Subject: Revision 1 to Transnuclear, Inc. (TN) Application for Amendment 2 to NUHOMS® HD Certificate of Compliance No. 1030 for Spent Fuel Storage Casks (Docket No. 72-1030, TAC No. L24691)

Reference: Letter from Lucieann Vechioli (NRC) to Don Shaw (TN), "Application for Amendment No. 2 to NUHOMS® HD Certificate of Compliance No. 1030 for Spent Fuel Storage Casks – Request for Supplemental Information," December 5, 2012 (Docket No. 72-1030, TAC No. L24691)

REQUEST FOR SUPPLEMENTAL INFORMATION**RSI-1:**

Figure 7-1
Typical 32PTH DSC Confinement Boundary

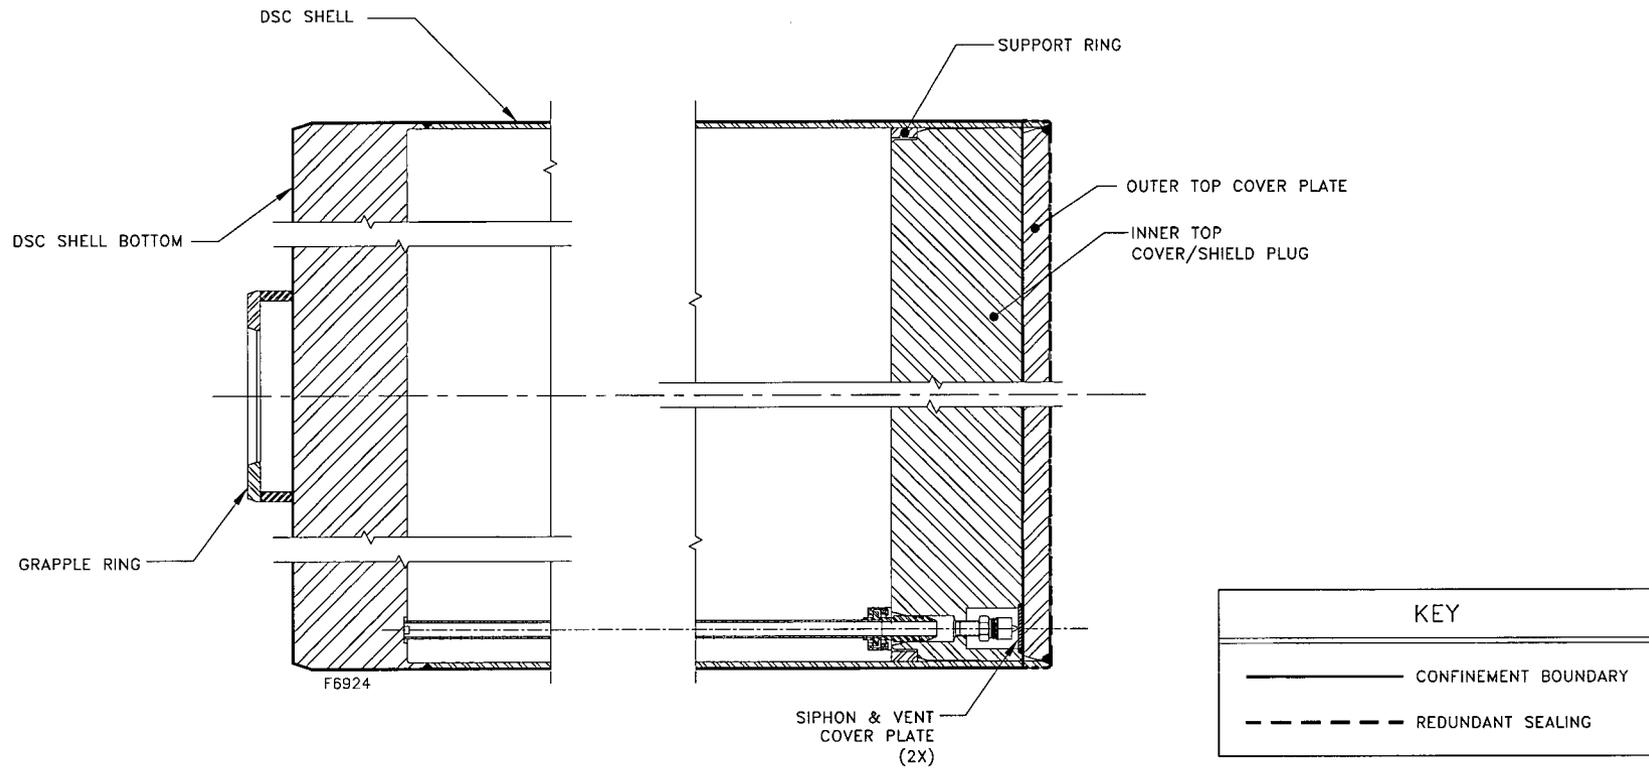
Provide an illustration of the confinement boundary and redundant sealing system in Figure 7-1 of the FSAR (e.g., solid and dashed lines to show the confinement boundary and redundant sealing system for the DSC).

A figure showing the confinement boundary and redundant sealing system is needed to accept the provision of redundant sealing of confinement systems.

UFSAR Figure 7-1 is revised to show both the confinement boundary (shown as a solid line on the revised figure) and the redundant sealing system (shown as a dashed line on the revised figure) of the 32PTH DSC.
